# PEDESTRIAN MASTER PLAN

## WORK SESSION #1

The Planning Board will discuss public testimony on the *Pedestrian Master Plan*, both oral and written, received before the closing of the public record on April 6, 2023.

April 6, 2023

A tactile crosswalk in the center of the painted crosswalk in Japan. Courtesy: Wikimedia

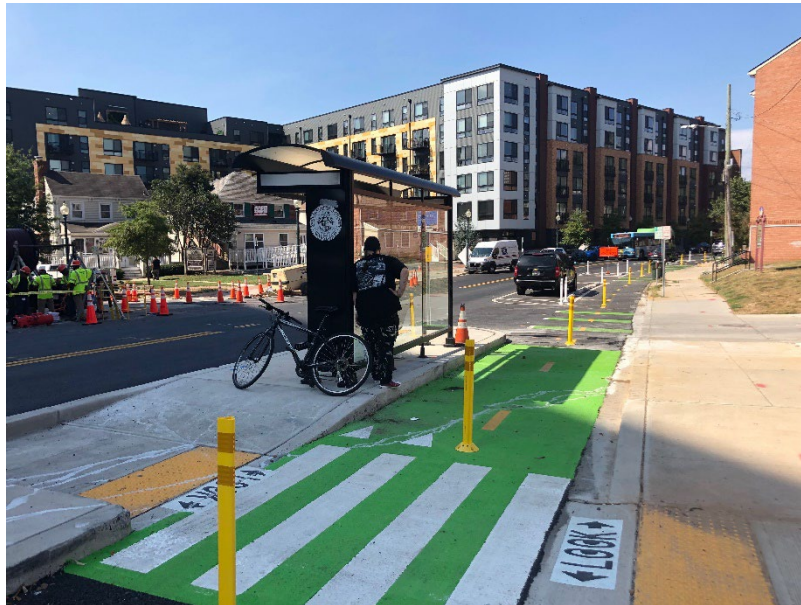
*Tactile crosswalks should be installed so a blind person can easily figure out where they are.*

**Planning Staff Response:** Agree. A tactile crosswalk is a crosswalk that has tactile delineator strips down the middle or along both sides of a crosswalk to help people with vision disabilities successfully navigate across the street. This treatment is included in MCDOT's *Planning and Designing Streets to be Safer and More Accessible for People with Vision Disabilities* document and Planning staff will work with MCDOT staff to implement it.
